## **SERVICE BULLETIN**

Bulletin No: JC-018-09

### **Possible wrong nut on 16cc pump pulley – F series BOB-CAT units only**

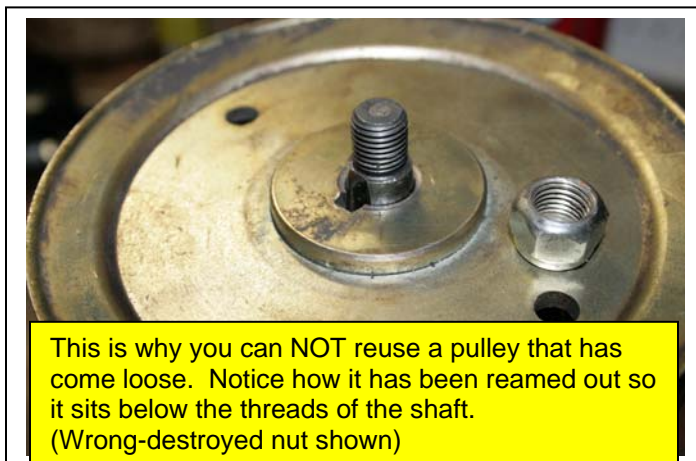
**Issue:** Due to a supply error there is a possibility that the Nylock nut on the 16cc pump pulley is slightly too tall, resulting in not enough of the threaded portion of the pump shaft passing through the locking nylon portion of the nut (the part number for the nut has always been correct and parts supply was not affected). This creates a distinct possibility of the nut backing off the pump shaft causing the pump pulley to come loose resulting in a loss of drive.

If you see the wrong nut, as illustrated in the following pictures, and the pulleys have not worked loose, simply swap out the nut. Torque the new nut to 50ft lbs of torque.

**Correction:** Replace the Pulley, Nut and Key if the pulley actually came loose. Reusing the pulley and key is fine if the pulley has not actually worked loose. **DO NOT REUSE THE NUT UNDER ANY CIRCUMSTANCE**. The reason for this will be explained in pictures that follow. Cleaning up the shaft may be required if the keyway got hammered. This too, is explained in the following pictures.
